Document Type: EIS-Administrative Record
Index Field: Final Environmental Document
Project Name: Single Nuclear Unit at the Bellefonte Site
Project Number: 2009-22

FINAL SUPPLEMENTAL ENVIRONMENTAL IMPACT STATEMENT

SINGLE NUCLEAR UNIT AT THE BELLEFONTE PLANT SITE

MAY 2010

Figure 2-1. B&W Site Plan

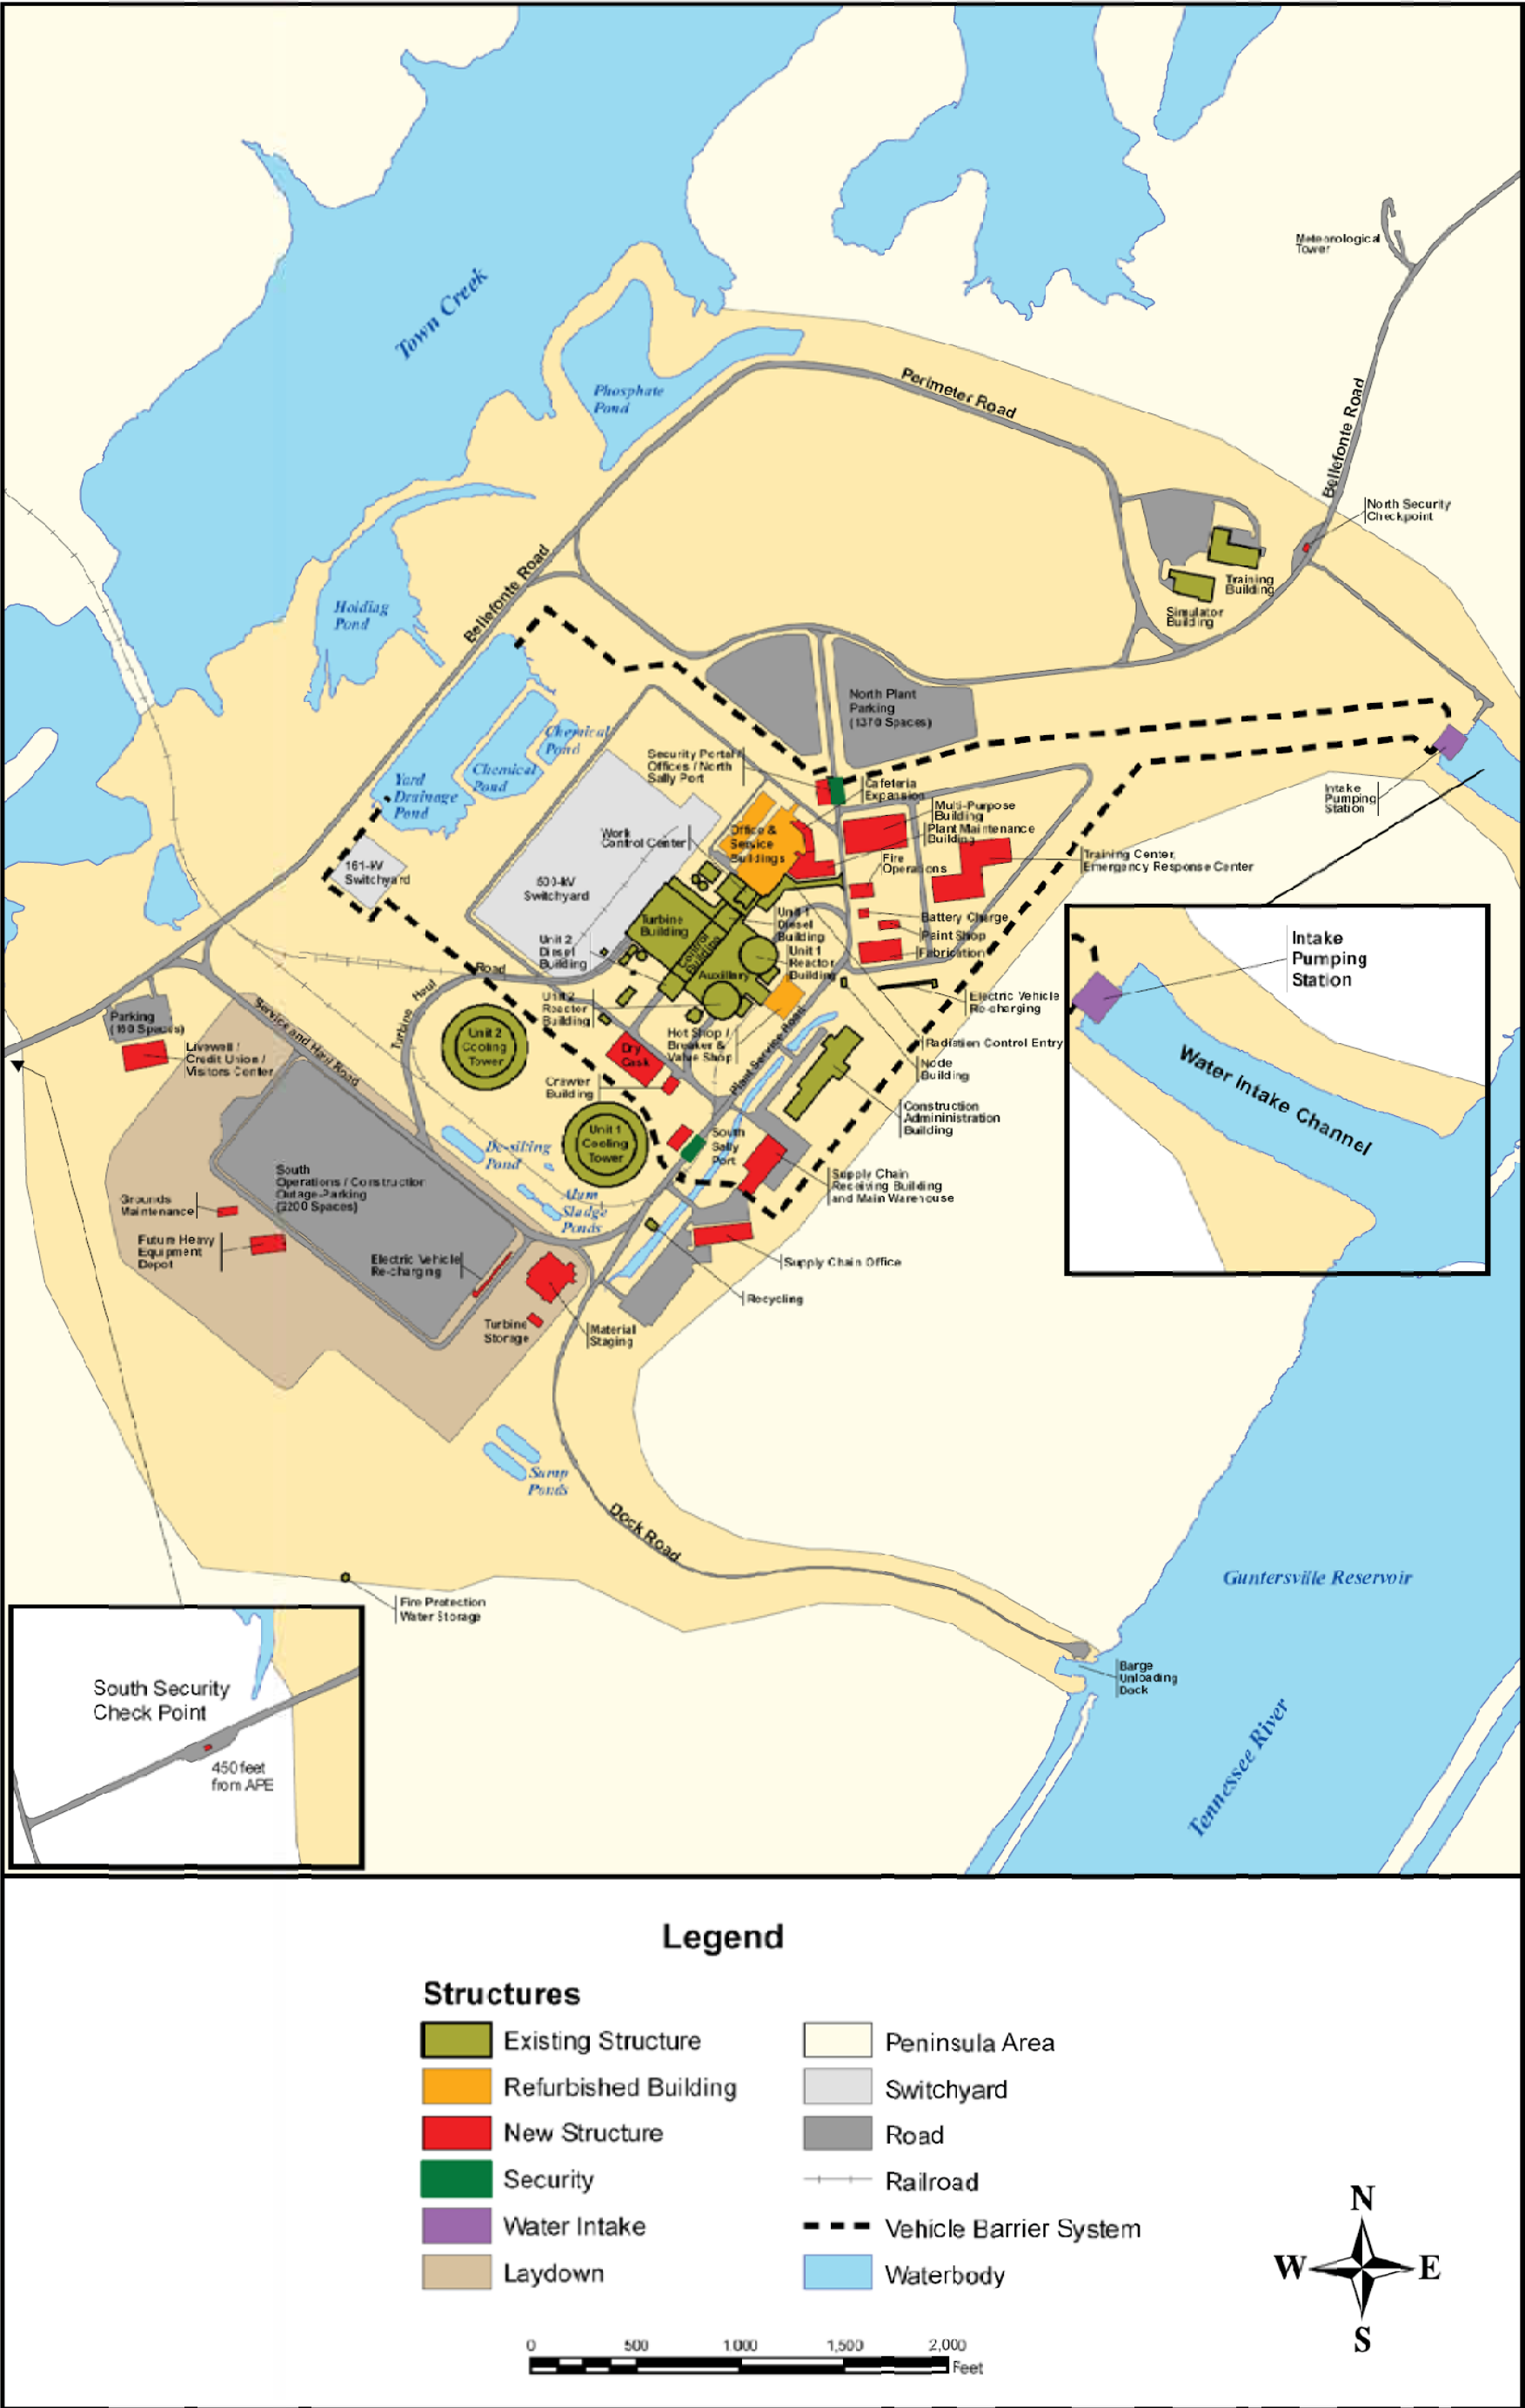
o **Figures** – Assumed Figure 2-1 is not numbered in the DSEIS. Also, we suggest that Figures 3-2, 3-3, and 3-4 label the identified “submerged diffuser” area as the plant discharge site for clarity, as was done in Figure 3-5.

Response: The site layout for the B&W and AP1000 reactor units are shown in FSEIS Figures 2-1 and 2-12 respectively. Figures providing the release vents, building heights, and receptor locations, for both the B&W and AP1000 reactor units, have been added to FSEIS 3.16.1.2.

Figure 3-3. B&W Unit 1 Water Intake and Discharge Facilities

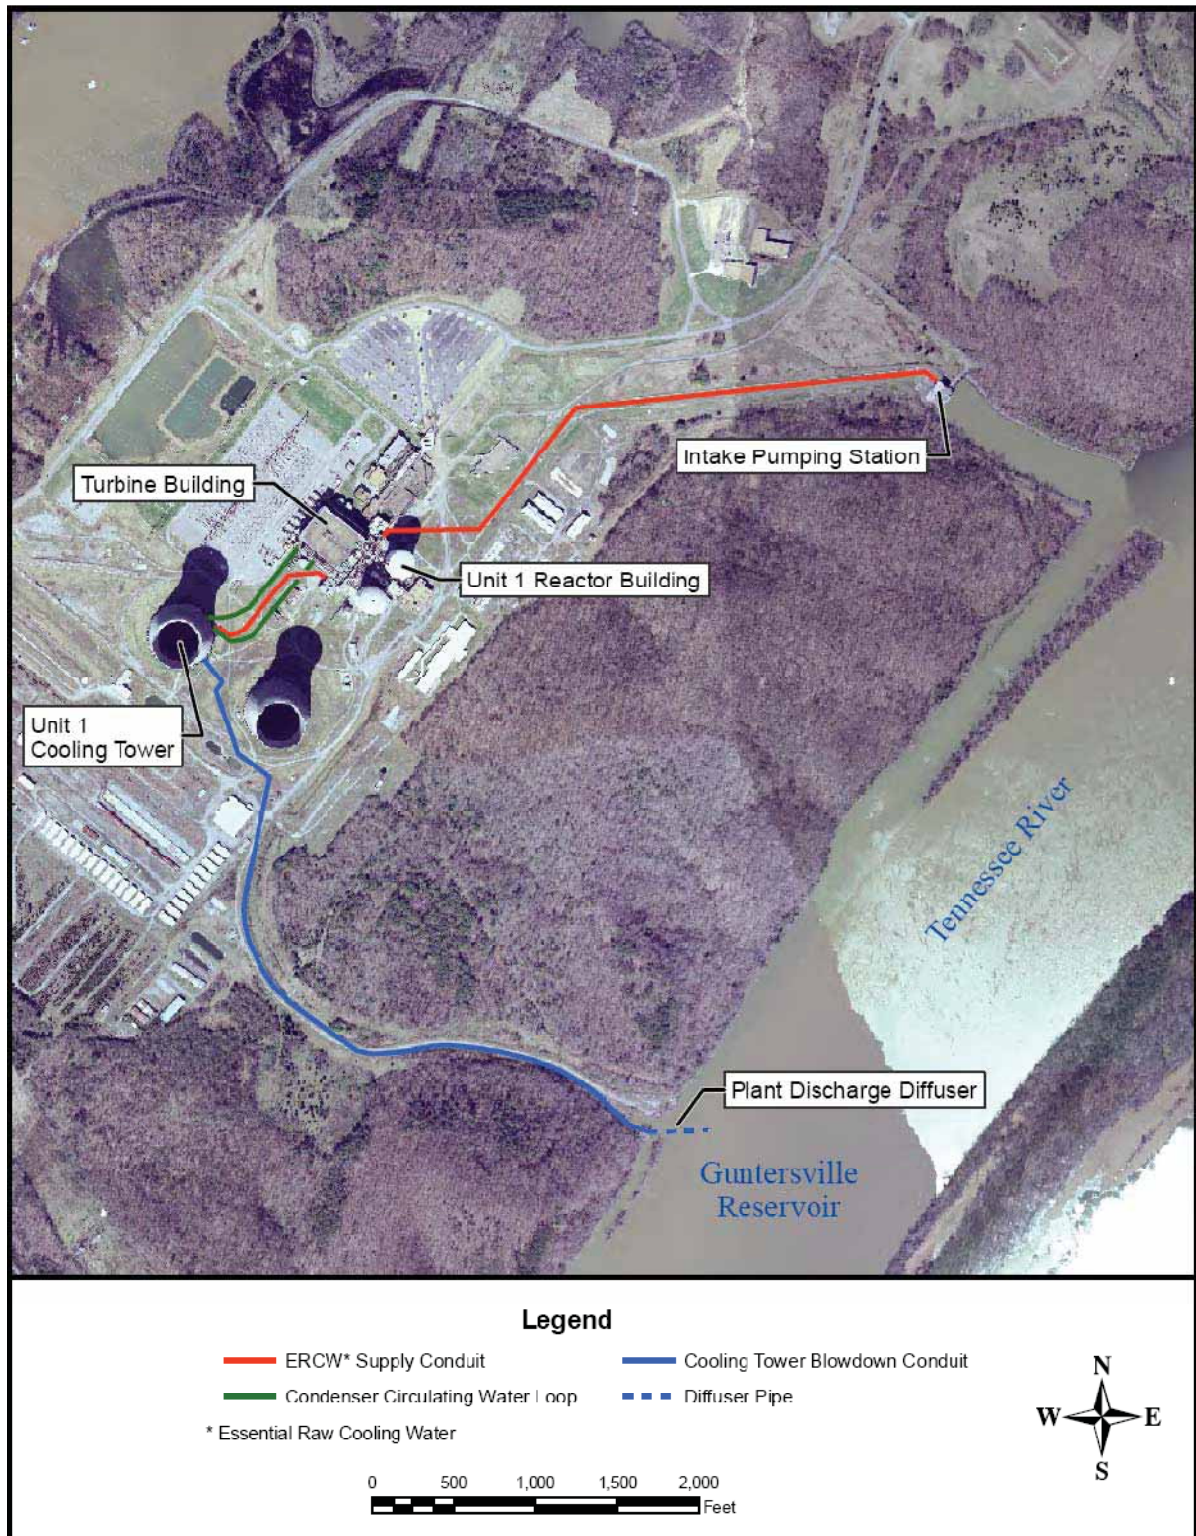
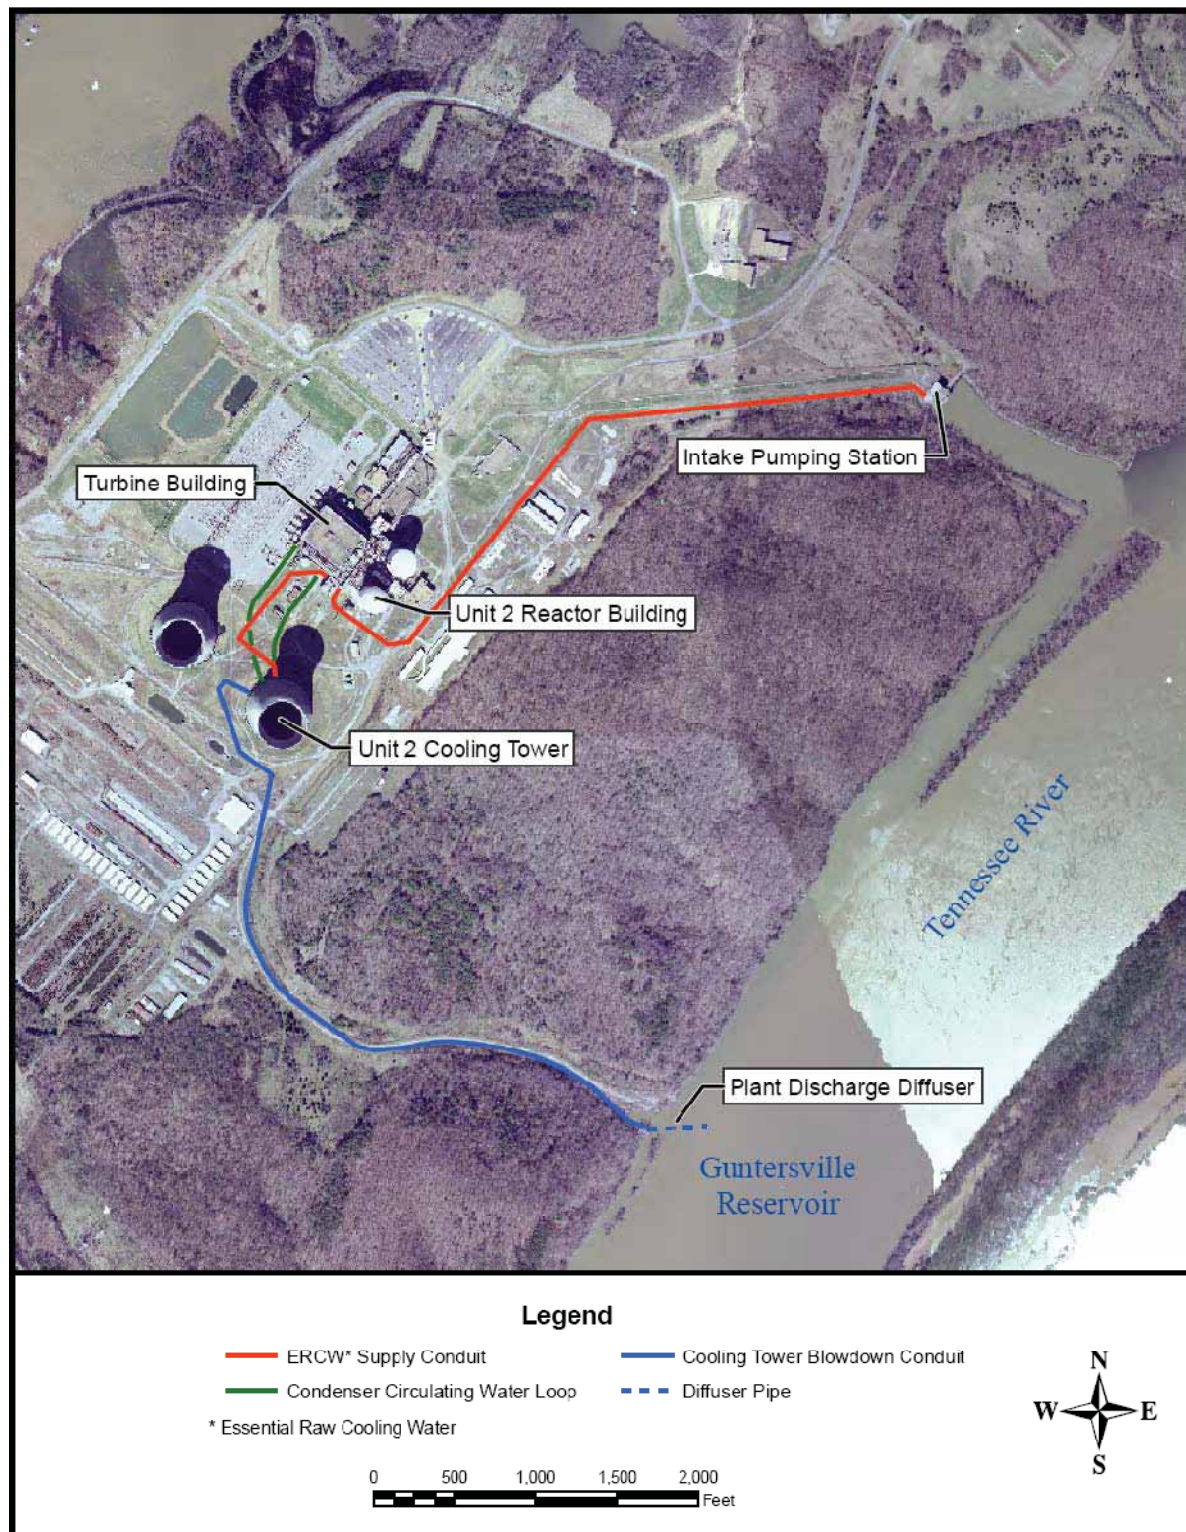
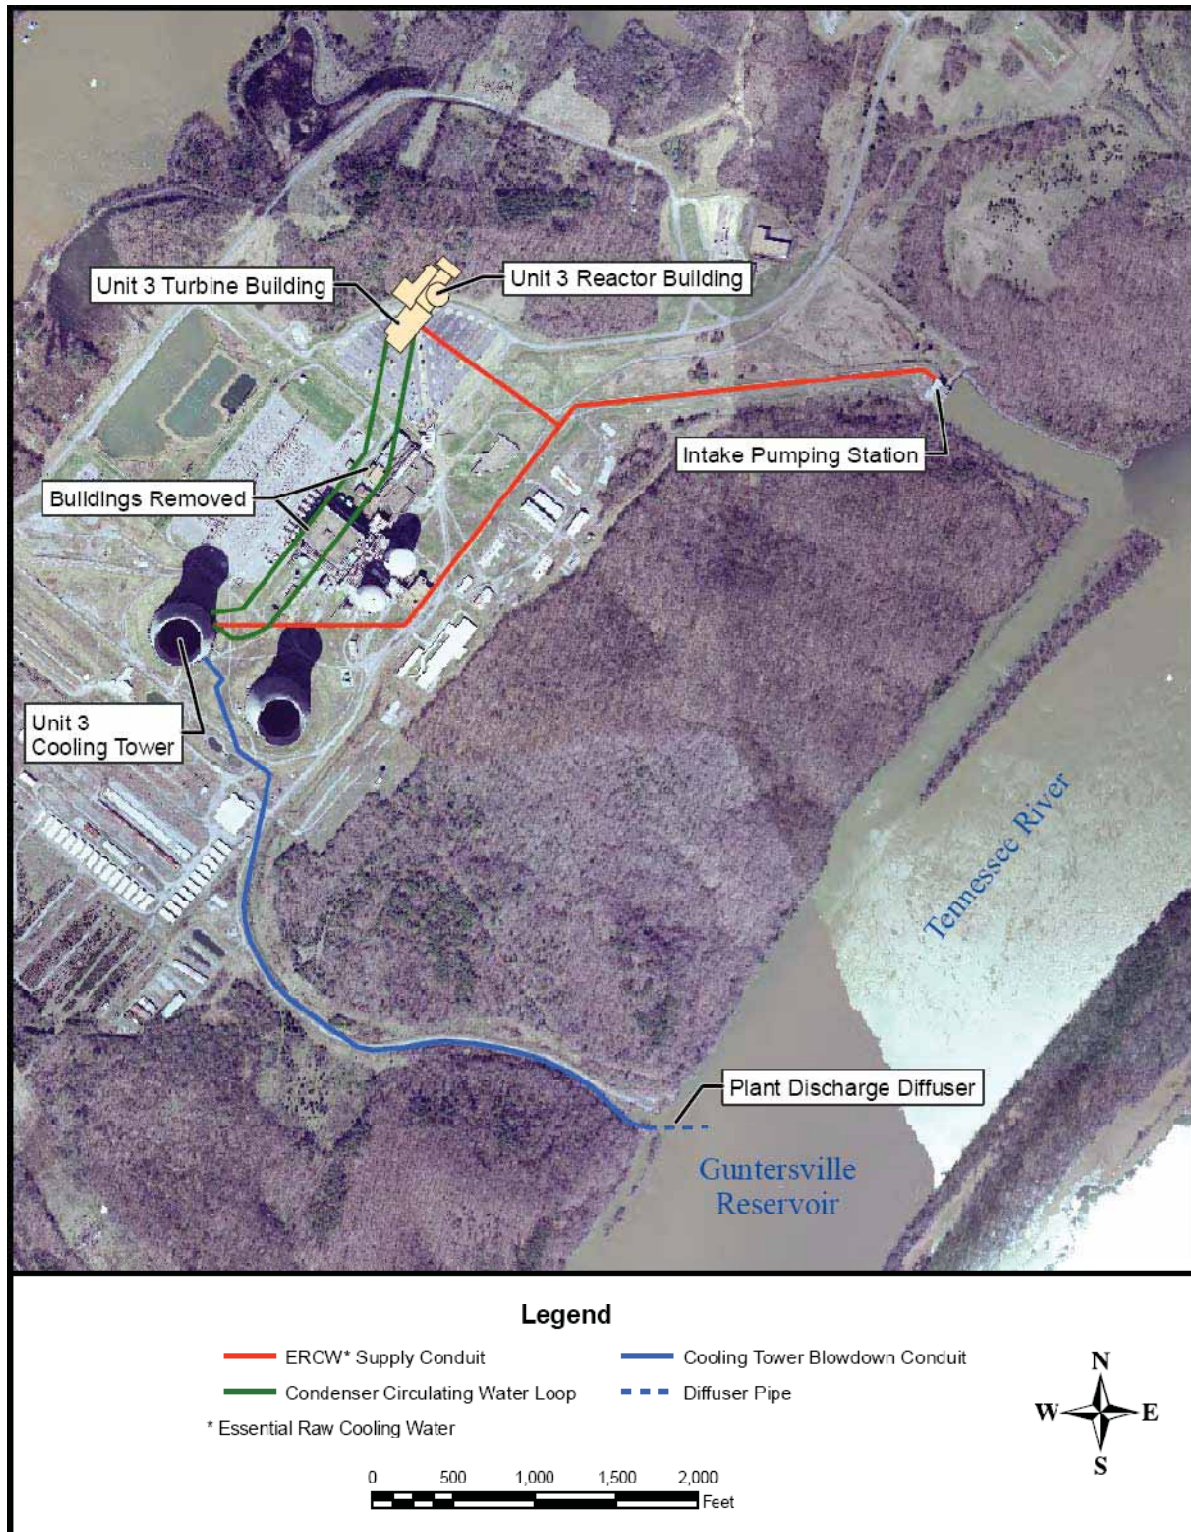
EPA73. Assumed Figure 2-1 is not numbered in the DSEIS. Also, we suggest that Figures 3-2, 3-3, and 3-4 label the identified “submerged diffuser” area as the plant discharge site for clarity, as was done in Figure 3-5.

Response: Figure 2-1 is labeled in the FSEIS and is listed in the Table of Contents. The suggested revision has been made to FSEIS Figures 3-3, 3-4 and 3-5.
